APPENDIX N

N2
RESPONSE TO LA-CITY LEA COMMENTS
SUNSHINE CANYON LANDFILL CITY-COUNTY JTD
FEBRUARY 27, 2008

RE: RESPONSE TO LA-CITY LEA COMMENTS
SUNSHINE CANYON LANDFILL CITY-COUNTY JTD

RE: **RESPONSE TO LA-RWQCB COMMENTS**
SUNSHINE CANYON LANDFILL CITY-COUNTY JTD

FIGURE C-C1

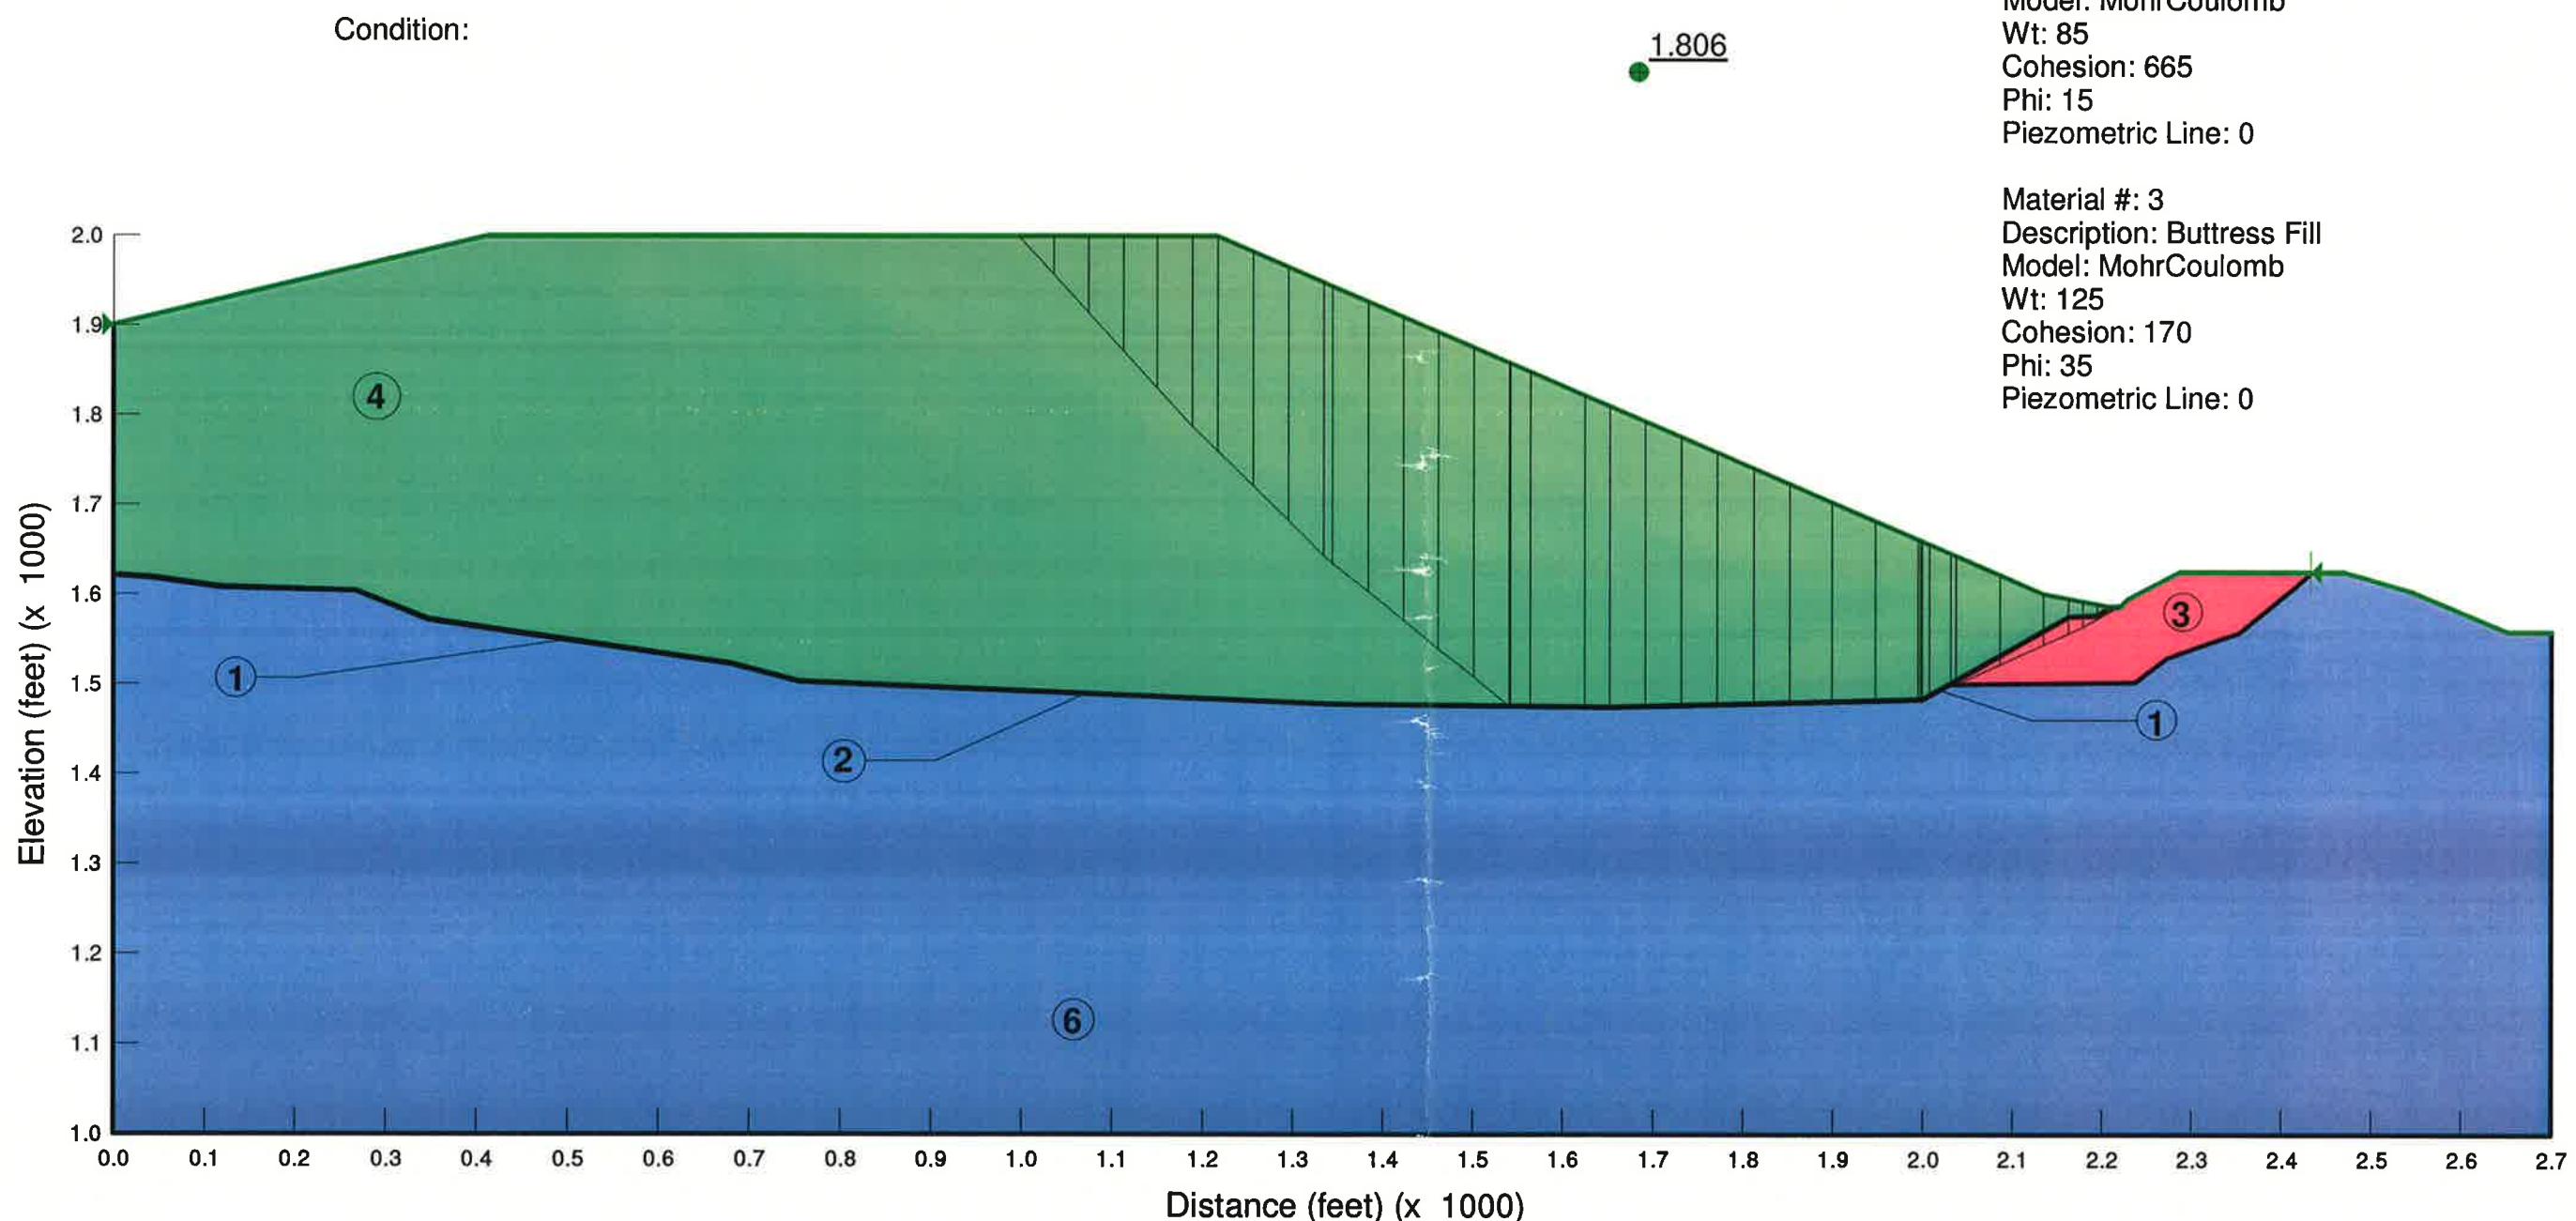
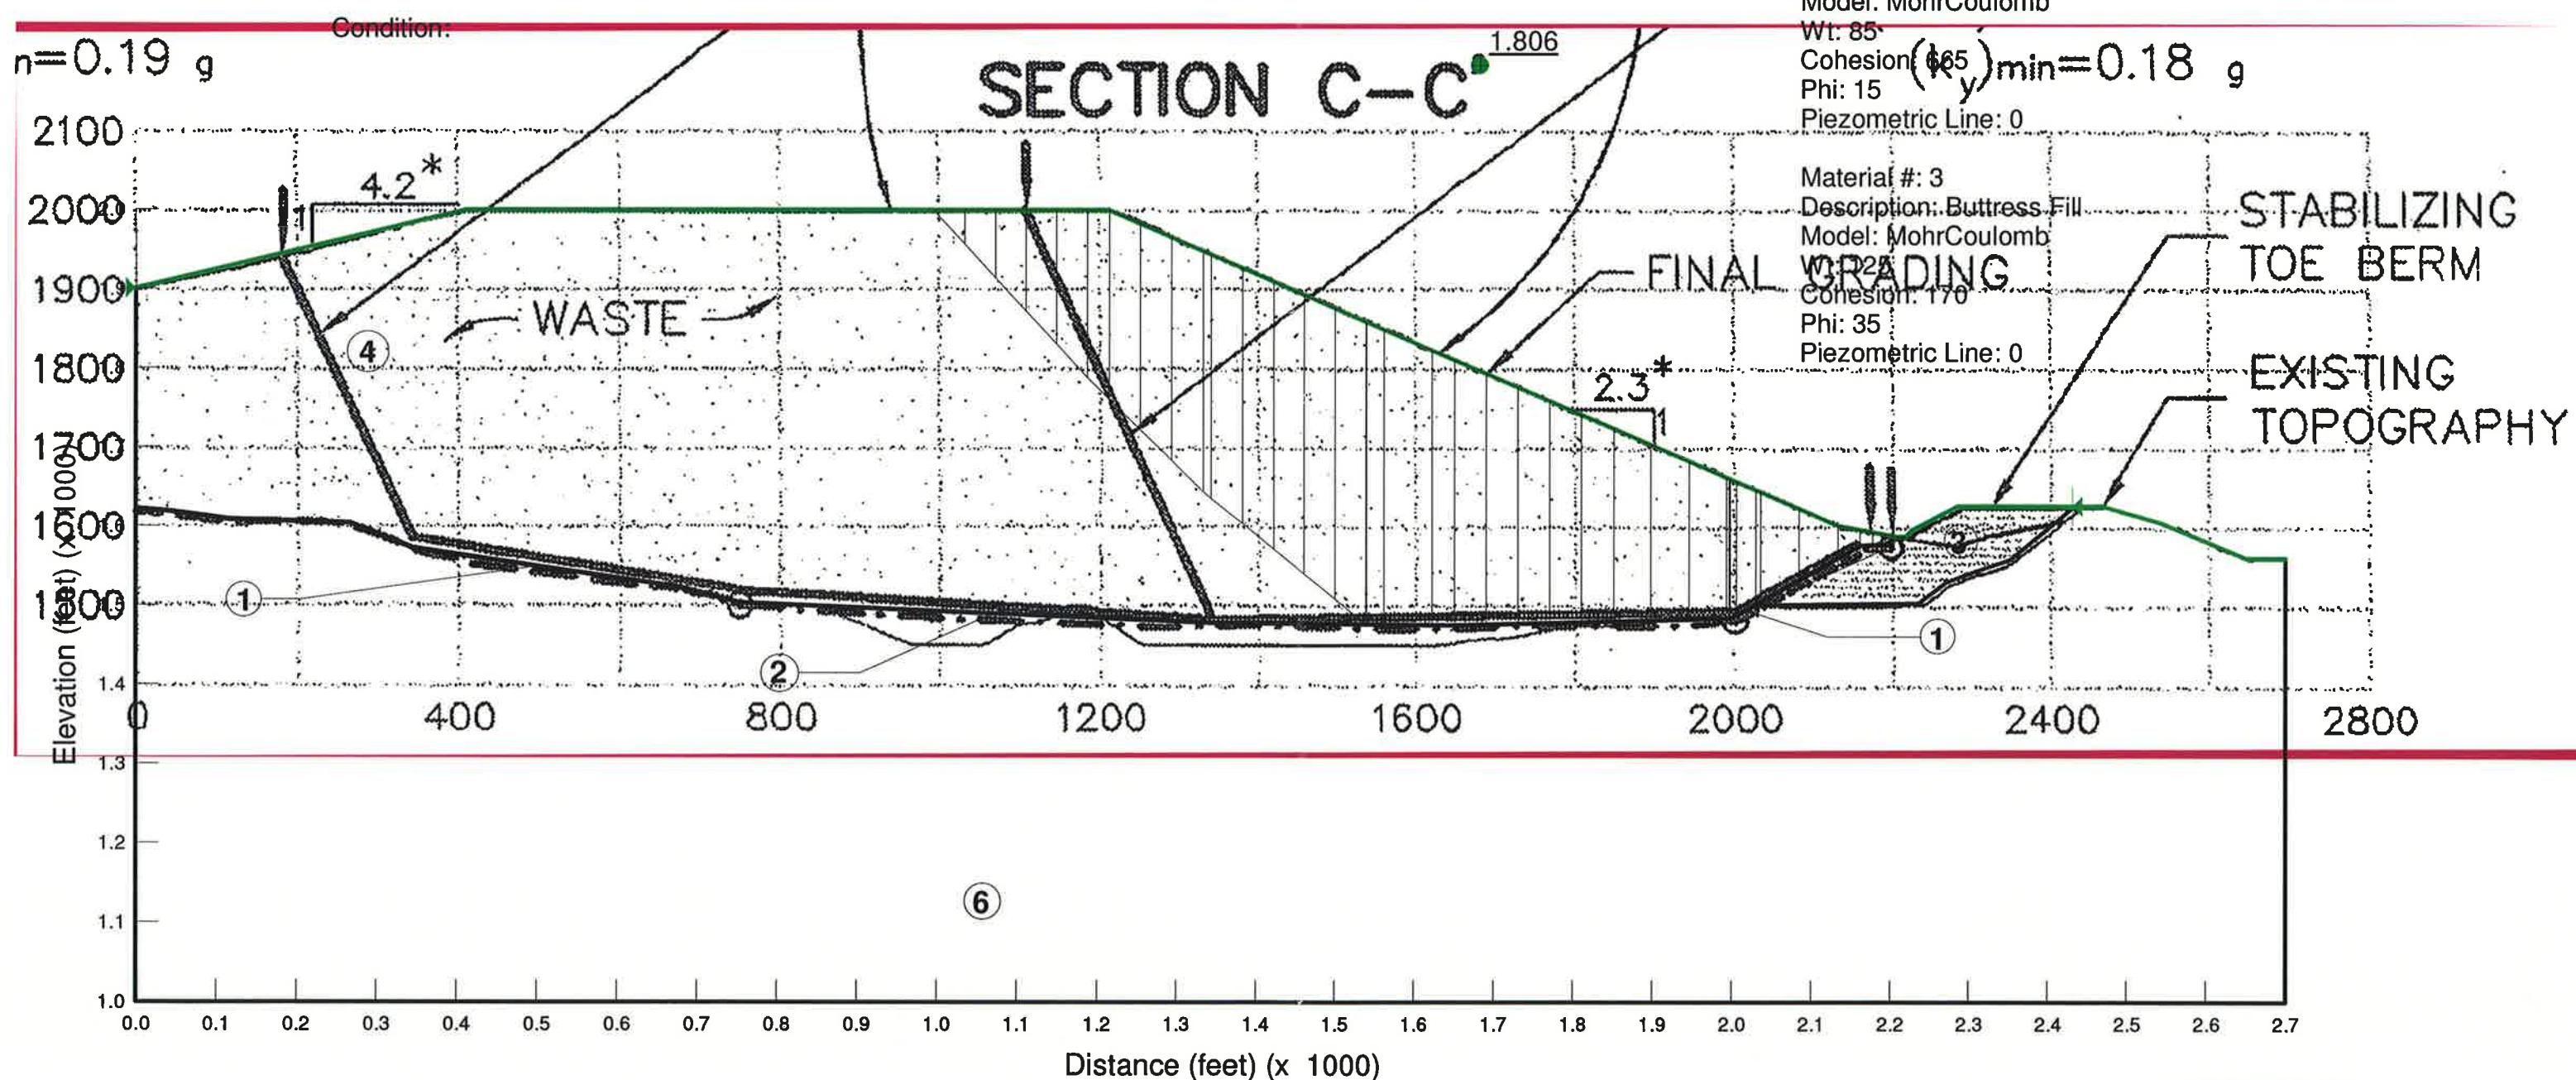
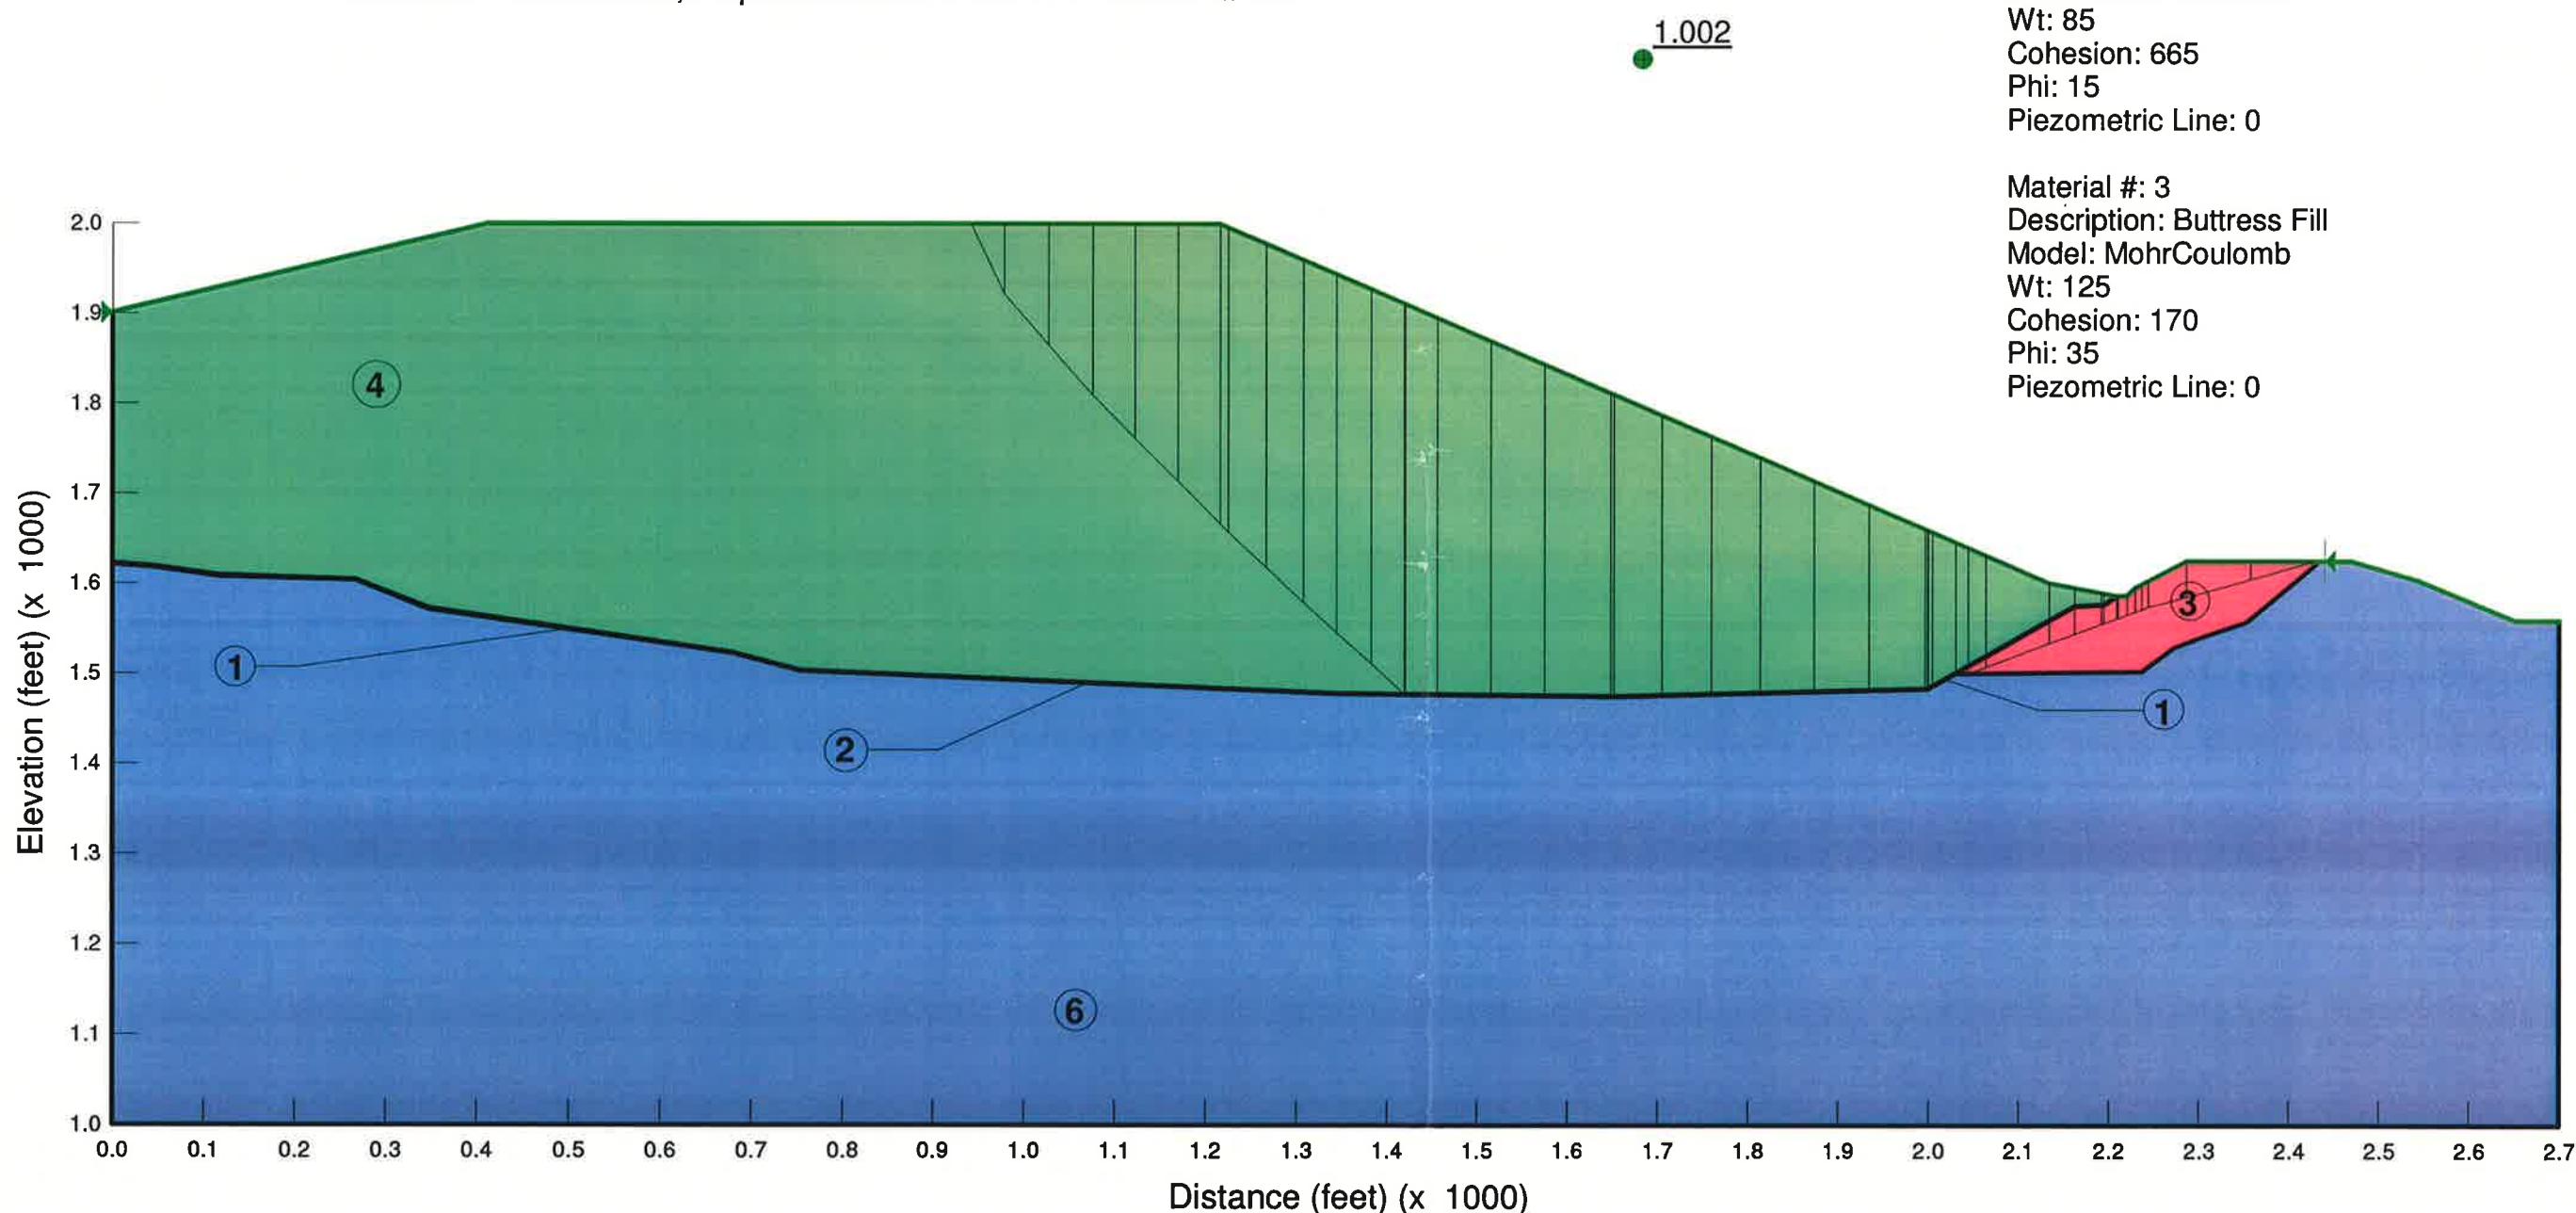
Appendix M, Excavation Slope Stability Analysis and Final Refuse Fill Slopes, Figure 7-6, and Figure 7-7, and Figure 7-8, Section C-C' and Section D-D'; The Section C-C' and Section D-D' slope stability analyses cross section have a stabilizing toe berm which abuts next to "existing topography". The "existing topography" in the area of the previous closed/inactive City Landfill.

Figure 7-7 and Figure 7-8 should show the MSW portion in the cross section depiction. Please differentiate the portions that are soil, and the portions that are MSW. Please also confirm that in the assessment of the slope stability, the modeling took into consideration of the lower density of the MSW at the toe of the proposed landfill expansion."

Cross Section C-C'

The extent of proposed waste is correctly shown in Cross Section C-C' (Figure 7-7). The buttress shown in this figure, which is currently in place, was constructed with compacted soil, however, not with roller-compacted concrete as shown in the figure. Since the potential stability failure surfaces presented in this figure run up the side slope liner at the toe, rather than through the stronger buttress, the stability analysis results presented in Figure 7-7 remain the critical analyses. As presented in Figures C-C1 to C-C3, the static factor of safety for a failure through the buttress at Cross Section C-C' is 1.81, and the pseudo-static yield acceleration is 0.30g; both of these parameters are less critical than the analyses presented in Figure 7-7. The stability analyses for potential failures through the buttress at Cross Section C-C' are presented herein three times: a static analysis with the material types clearly shown (Figure C-C1), a second identical analysis shown with the Figure 7-7 superimposed (Figure C-C2), and a pseudo-static analysis (Figure C-C3). Note that for all analyses presented with this memorandum, the material properties used, such as shear strength and unit weight, were identical to those used in the 2002 JTD analyses; as such, the density of 85pcf used for municipal solid waste (MSW) is consistent with current practice.
